Planning Board

PUBLIC MEETING TOWN OF HUDSON, NH AUGUST 16, 2017

A. American Tower Corporation Site Plan & Conditional Use SP# 07-17 & CU# 01-17

PLAN UNDER REVIEW ENTITLED: American Tower, Hudson, NH, Site #: 202096, 143 Dracut Rd., Hudson, NH, prepared by: Patrick P. Barry, NH LPE, dated: 11 JUL 2107, last revised 10 JUL 17, consisting of Sheets 1 – 11 (namely: G-001, V-101, V-102, C-101, C-401 – 404, C-501 - 503, and Project Notes 1 – 5, shown on Sheet G-001 (said plans attached hereto).

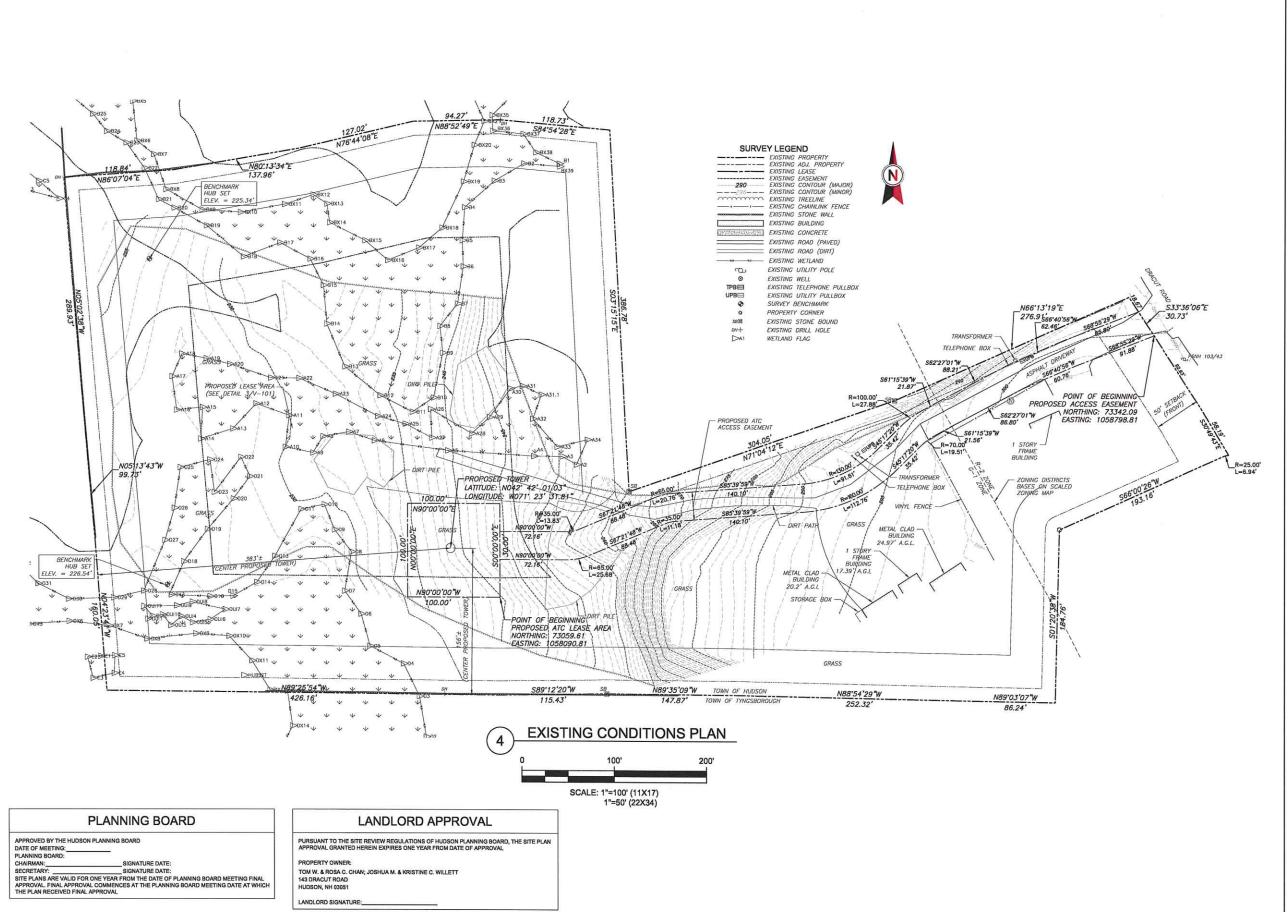
- Current CLD Comment: The applicant has provided a more legible location plan on the cover sheet. A scale for this plan is not noted. The applicant has directed use of the Vicinity Map on Sheet V-101 to meet the requirement; however, the scale of the Vicinity Map on Sheet V-101 does not meet the Regulation (1:1000 scale).

Current CLD Comment: The applicant has provided a more legible location plan on the cover sheet. A scale for this plan is not noted. The applicant has directed use of the Vicinity Map on Sheet V-101 to meet the requirement; however, the scale of the Vicinity Map on Sheet V-101 does not meet the Regulation (1:1000 scale)

- Expiration has been added to sheets V-101 and V-102
- o. Former CLD Comment: HR 276-11.1.B.(8). The applicant has provided a location plan on the cover sheet. The plan does not include a scale and is not very legible. Another plan sheet includes a vicinity map at 1:2000 scale.

V-102

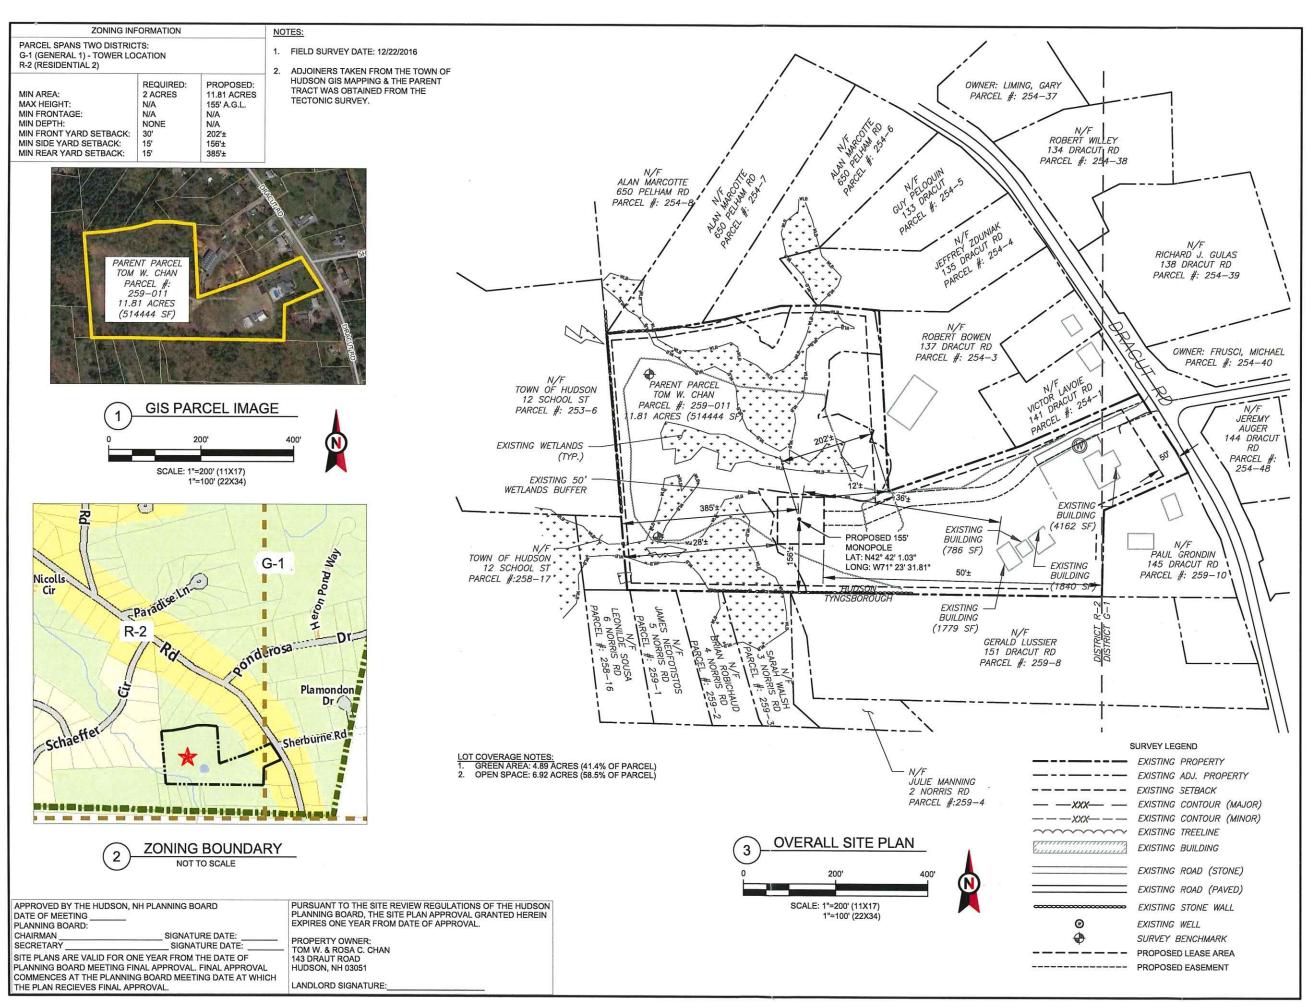
- Current CLD Comment: The applicant has shown a proposed access easement on the plans and forwarded a copy of an existing slope and embankment easement. The applicant noted that the existing easement is depicted on Sheet V-102; however, we were unable to find the easement on the plan.

- k. Former CLD Comment: HR 276-11.1.B.(4)(b). The approval block is only located on the cover sheet, not each plan sheet as required by Regulation.
 - **Current CLD Comment:** The applicant has added the approval block to all plan sheets except Compound Detail sheet V-101 and Existing Conditions sheet V-102.

- Current CLD Comment: The applicant has added the expiration of approval language to all of the plan sheets except Compound Detail sheet V-101 and Existing Conditions Sheet V-102. The note is not written in the specified two inch by one and one-half inch space (2"x1-1/2").

Current CLD Comment: The applicant has shown a proposed access easement on the plans and forwarded a copy of an existing slope and embankment easement. The applicant noted that the existing easement is depicted in Sheet V-102; however, we were unable to find the easement on the plan.

Current CLD Comment: The applicant has added the approval block to all plan sheets except Compound Detail sheet V-101 and Existing Conditions sheet V-102

Current CLD Comment: The applicant has added the expiration of approval language to all of the plan sheets except Compound Detail sheet V-101 and the Existing Conditions sheet V-102. The note is not written in the specified two inch by one and one-half inch space (2"x1-1/2")

- Sheet V-102 has been updated
- g. **Former CLD Comment:** HR 275-9.G. No copies of applicable approvals or permits were provided in CLD's review package.

- Approval block has been added to sheets V-101 and V-102
- I. **Former CLD Comment:** HR 276-11.1.B.(5). The applicant has not provided the approval block language regarding expiration of approval as required by the Regulation.

C-101

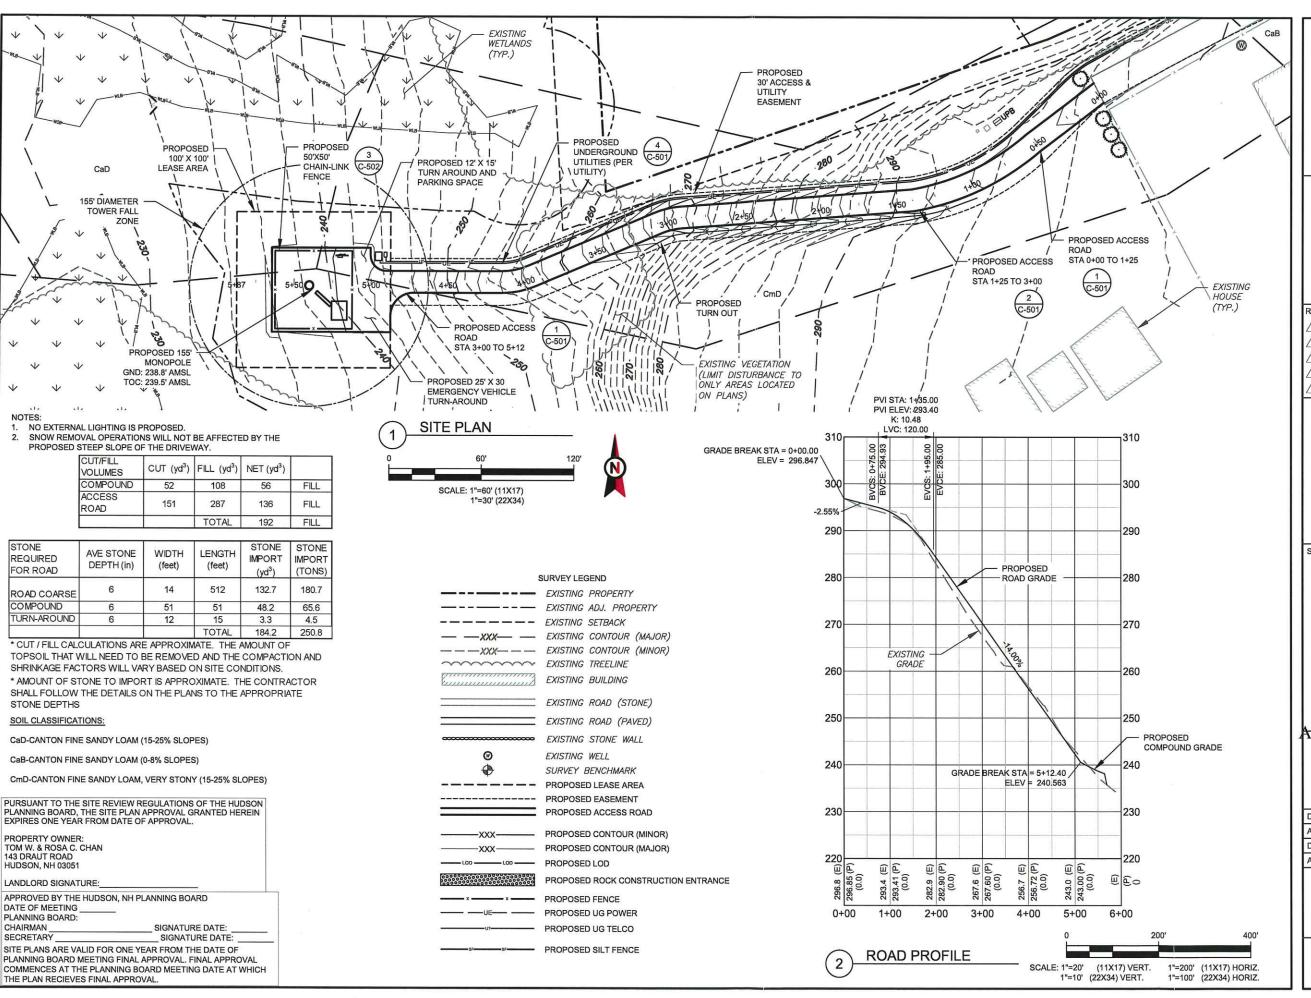
- w. Former CLD Comment: HR 276-11.1.B.(24). The applicant has not provided open space lot coverage calculations.
 - Current CLD Comment: The applicant has added lot coverage notes to plan sheet C-101, but has not provided the corresponding coverage percentages.

- c. Former CLD Comment: ZO 334-27.1. The applicant has not included setback lines or dimensions on the plans. The applicant has noted setback dimensions in a table on sheet C-101.

Current CLD Comment: The applicant has added lot coverage notes to plan sheet C-101, but had not provided the corresponding coverage percentages.

C-401

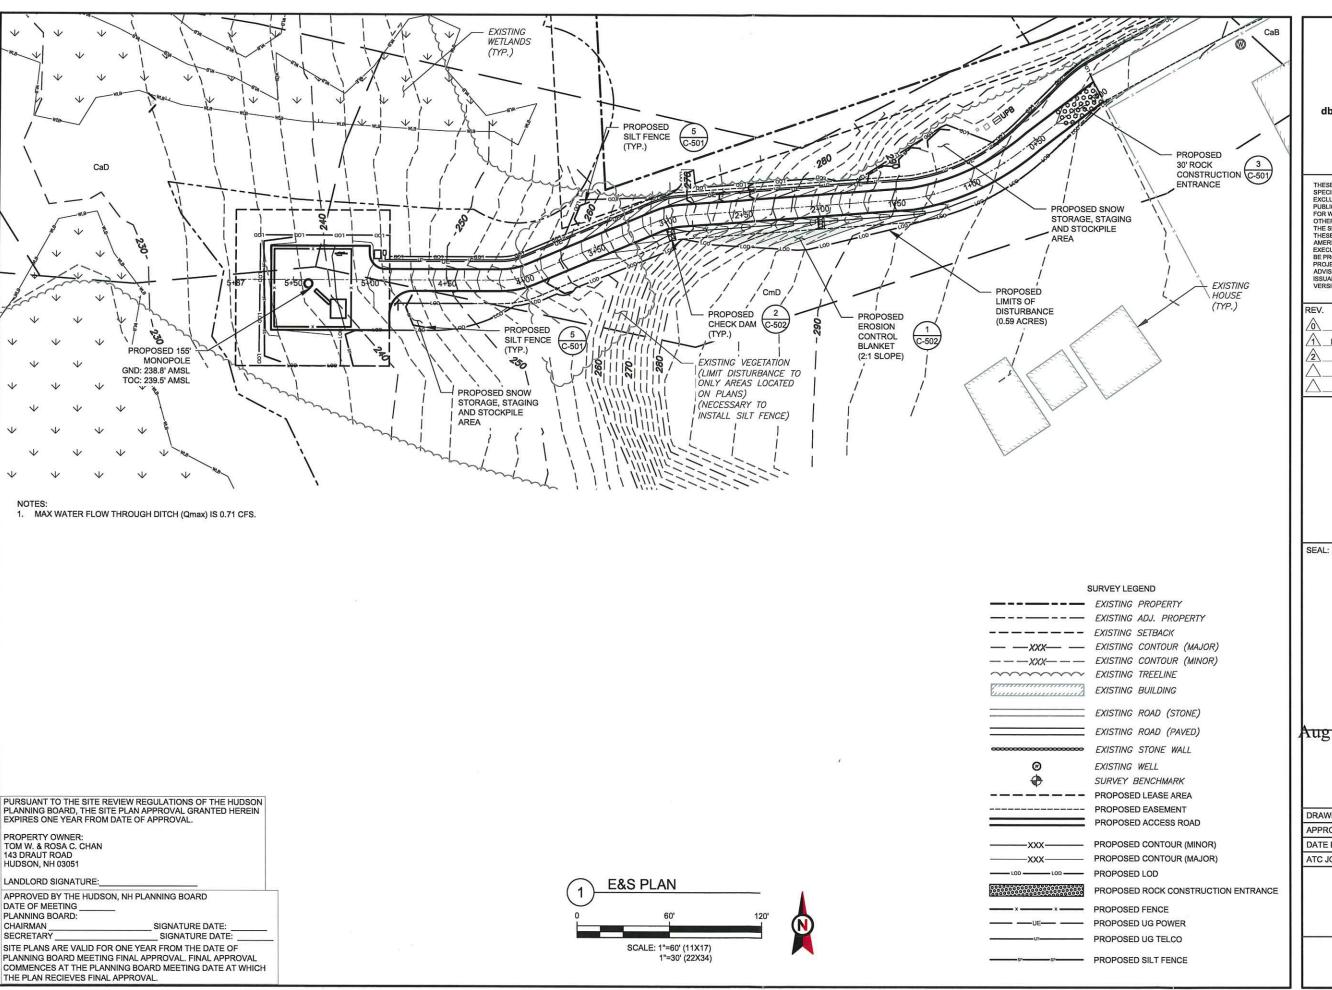
Current CLD Comment: The applicant has added a fall zone radius to plan Sheet C-401. We noted that the center of the 155' monopole is shown as 154' +/- from the southern property line of the site on Sheet C-101 (the property line is not shown in this proximity on Sheet C-401). The applicant should review the monopole location and provide an actual fall zone calculation to ensure that it is not capable of falling or collapsing beyond the bounds of the property on which it is situated.

Current CLD Comment: The applicant has added a fall zone radius to plan C-401. We noted that the center of the 155' monopole is shown as 154' +/- from the southern property line of the site on Sheet C-101 (the property line is not shown in this proximity on Sheet C-401). The applicant should review the monopole location and provide an actual fall zone calculation to ensure that it is not capable of falling or collapsing beyond the bounds of the property on which it is situated.

C-501

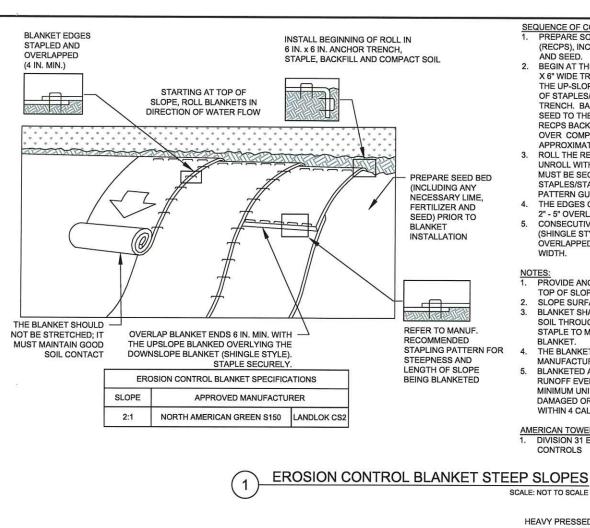
- b. Former CLD Comment: HR 290-5.L. The applicant should provide rip-rap stone size information for what is labelled "R3 Rip Rap" upon the plan set, plus include any supporting calculations illustrating that the stone size is adequate for the proposed flow.
 - Current CLD Comment: The applicant has noted that the R3 Rip Rap size is indicated on Plan Sheet C-501 and is typically 3"-6" stone. We continue to recommend that the specific size be added to the plan set.
- c. Former CLD Comment: HR 290-5.L. The applicant should note how much flow is anticipated for the level spreader.
 - Current CLD Comment: The applicant has removed the level spreader from the plans due to the flow being "fairly miniscule" (0.71 cfs as noted on the plans). Calculations were not provided that supported this assessment.

Current CLD Comment: The applicant has noted that the R3 Rip Rap size is indicated on the Plan Sheet C-501 and is typically 3"-6" stone. We continue to recommend that the specific size be added to the plan set.
